Service Bulletin

Amateur Radio Division

ASB-1030

Subject: TS-50S "HELLO" Displayed during TX

Final Unit (X45-3460-00) (B/2)
Foil side View

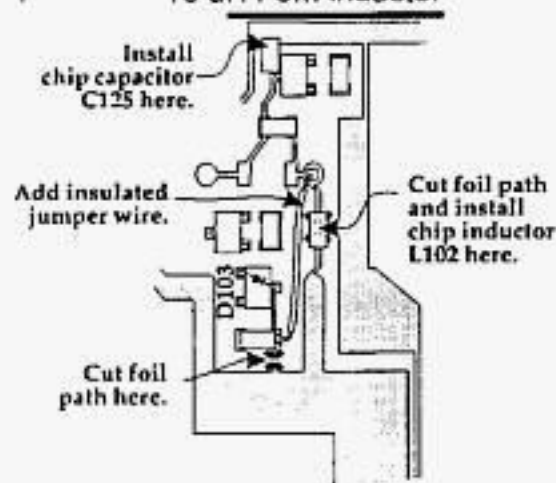
Occasionally an "HELLO" message will appear in the display of the transceiver when the TS-50S is loaded into an antenna without the use of an antenna tuner. This symptom usually occurs when the negative terminal of the power supply is floating (un-grounded for RF). This can result in RF feedback that causes the supply voltage to exceed 16 vdc.

1. Cut the Final Unit PC Board foil in two places, as shown below.
2. Add a .1uF chip capacitor (C125) as shown below.
3. Add a 10 uH chip ferri-inductor (L102) as shown below.
4. Add an insulated jumper wire as shown below.

Qty	Description	Kenwood Part No.	Circuit Description
1	.1uF Chip Capacitor	CK73EB1E104K	C125
1	10 uH Ferri-inductor	L40-1001-48	L102

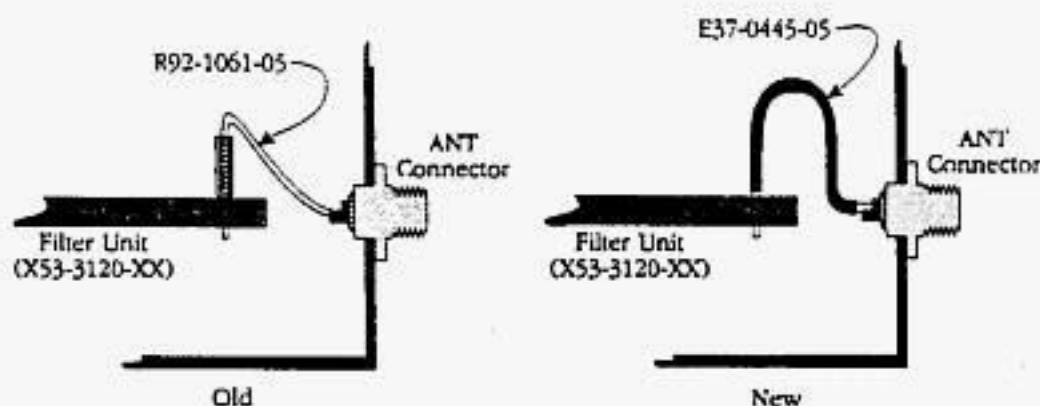
Several users have reported a problem with the antenna lead connection, i.e. the lead that connects the antenna connector to the Filter Unit (X53-3120-XX). Originally this connection was made by a zero ohm resistor. If excessive stress is placed on the antenna connector this lead is easily broken, with a resulting loss of receiver sensitivity and transmitter power. The use of a small flexible jumper wire will increase the flexibility of this connection, thus minimizing the effects of mechanical stress.

Remove the zero ohm resistor and replace it with the small piece of cable. See accompanying diagram.

Qty	Description	New Part No.	Circuit Description
1	Cable	E37-0445-05	W2
